SEWAGE DISPOSAL SYSTEM

MARYLAND STATE DEPARTMENT OF HEALTH

Allen's Backhoe Rental IS PERMITTED TO INSTALL _____ ALTER X
ADDRESS 15050 Carr's Mill Road, Wopdbine, Maryland PHONE 489-7095
SUBDIVISION Breezewood Farms ROAD 10635 Breezewood Dr LOT 7, Section 4
PROPERTY OWNER Mr. and Mrs. Robert Whiting
ADDRESS _____

REPAIR - PURPOSE - TO ACCOMMODATE BUILDING PERMIT NO. 30534 - addition.

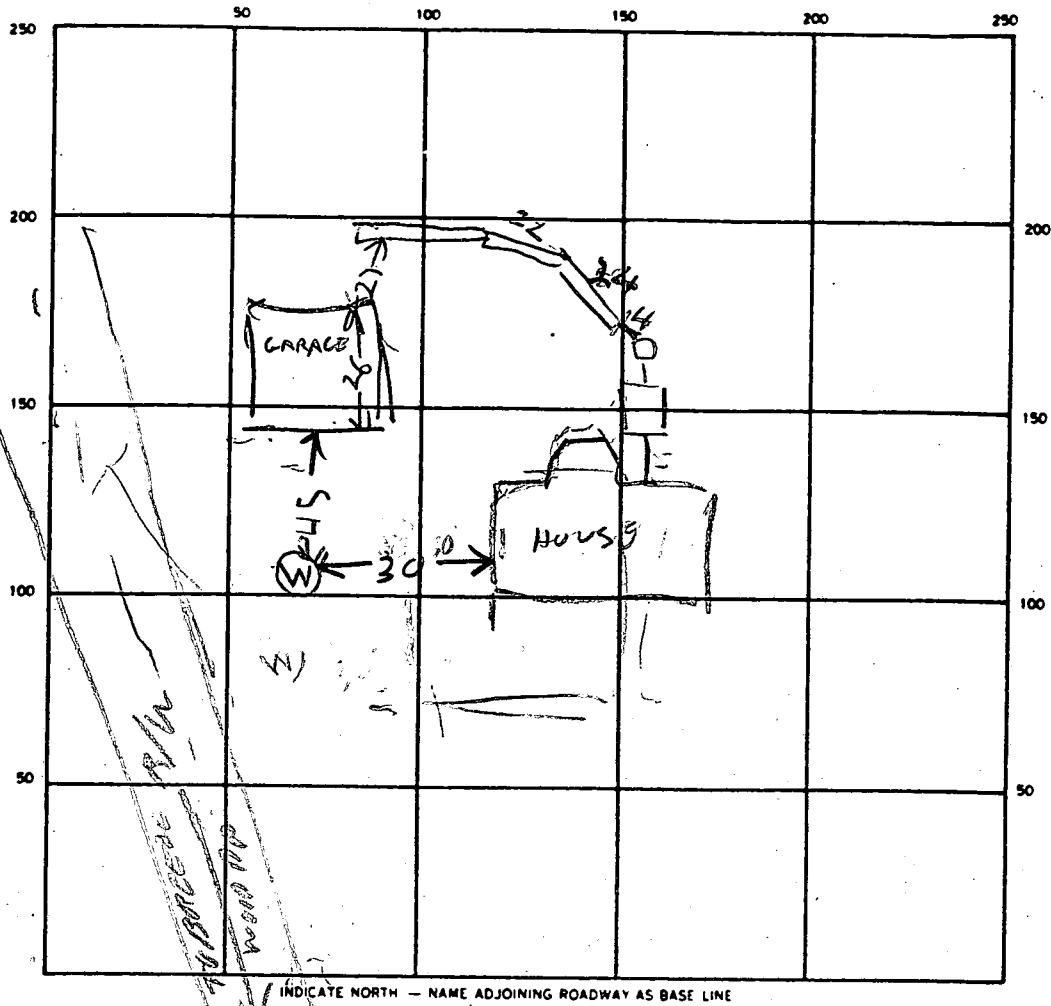
REMARKS 3/8/90 TANK OUTLET HAS WRONG WAY SLOPE & MUST BE FIXED TRENCH
NOT YET STARTED 3/9/90 - HALF OF TRENCH DUG & FILLED
WITH STONE. FINISH TRENCH BUT LEAVE END OPEN TO MEASURE
DEPTH. 3/9/90 TRENCH FINISHED

Health Department recommends 90 feet m/1 of trench. Trench to be 2 feet wide, Inlet 3 feet below original grade. Bottom maximum depth 7 feet below original grade with 4 feet of stone below distribution pipe. ok/cw

OK TO HAVE INLET ONLY 4 FT DEEP & 3 FT DEPTH OF STONE TIGHT ST

SITE PLAN

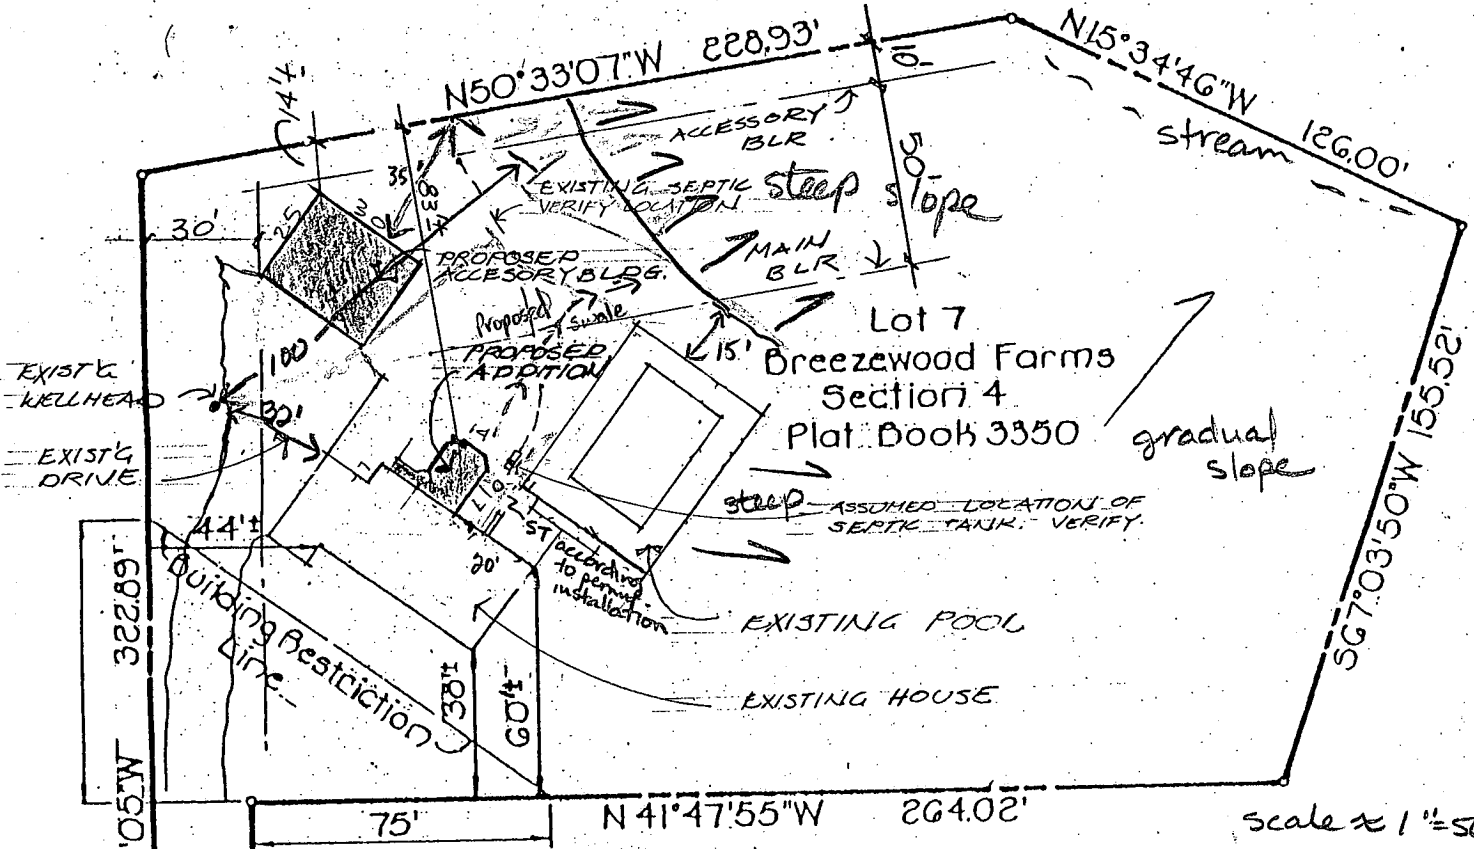
11-24-89 Must locate septic tank. septic tank appears to be too close to proposed addition. Swale may interfere with existing sewer line and trench. Repair permit needed to connect accessory bldg to septic system JEN

11-22-89 Extra building will be for crafts w/ lavatory and sink. Swale to lead rain runoff from driveway out of pool. Well is 100 ft to pool's lower end. No repair area recommended in yard where septic supposedly exists. No tank found. 3 bedrooms no garbage disposal in existing house. No overflow observed.

Slope seems > 25% where septic repair is indicated. Recommend review by supervisor. Septic tank is less than 10 ft to addition to house. JENadean

SEPTIC LOCATION 1/4" = 1'-0"

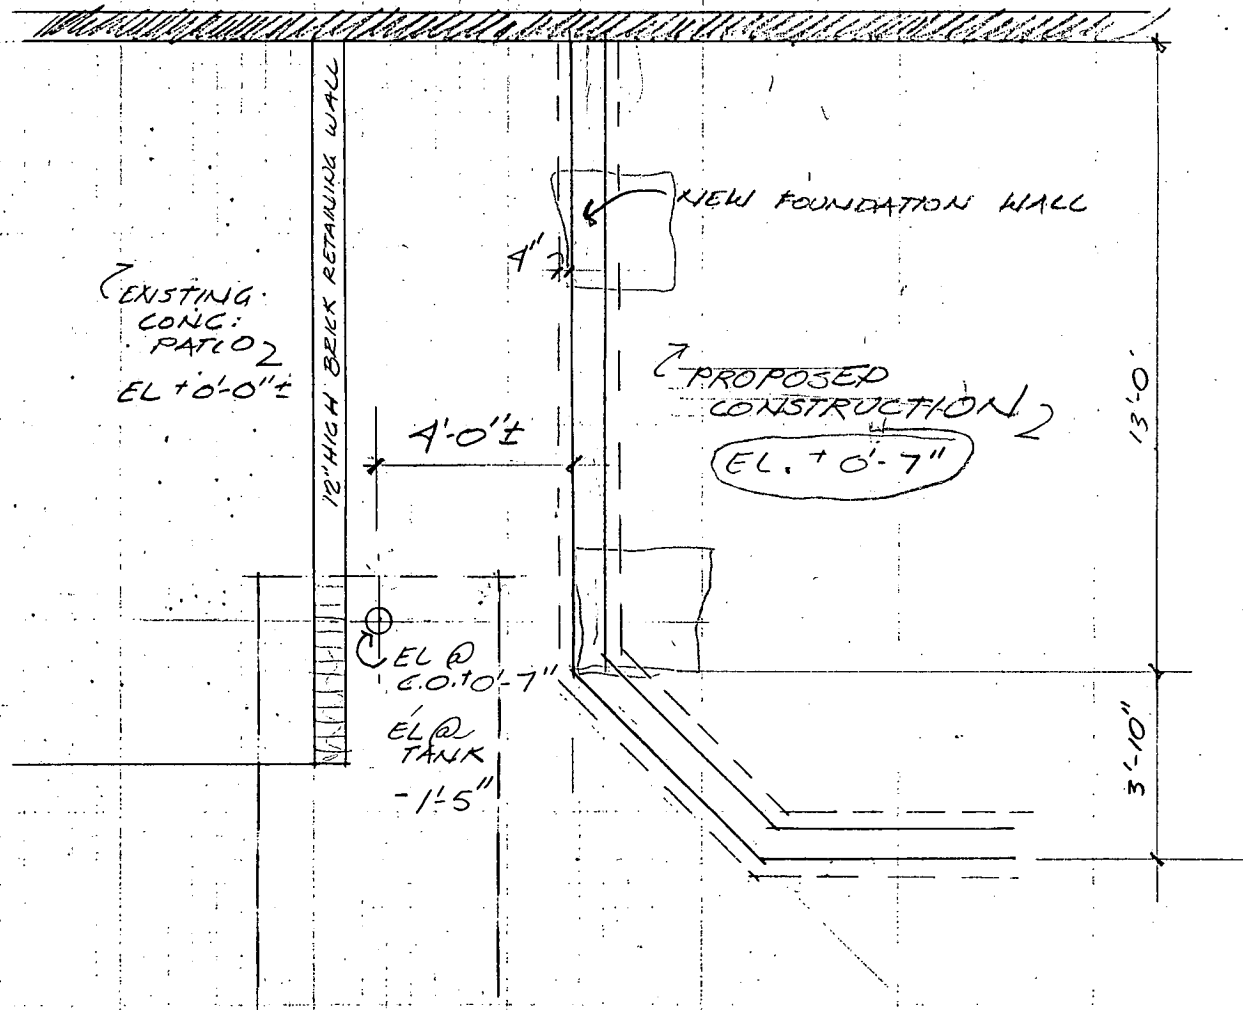
Existing septic tank located 4.0 ft from existing overhead deck. No building permit found for deck addition. Probably was not permitted in past.

Health Department recommends a repair to the existing system at this time to prevent excavation in near future if system should fail. Septic system is about 14 years old. Recommends extreme caution with construction around septic tank and do not destroy septic cleanout. ^{BUT DOES NOT REQUIRE}

For repair to system, Health Department recommends 90± ft of trench, bottom maximum of 7 ft with inlet at ~~#ft~~ 3 ft, 4.0 ft of stone in trench.

Recommends approval of building permit.
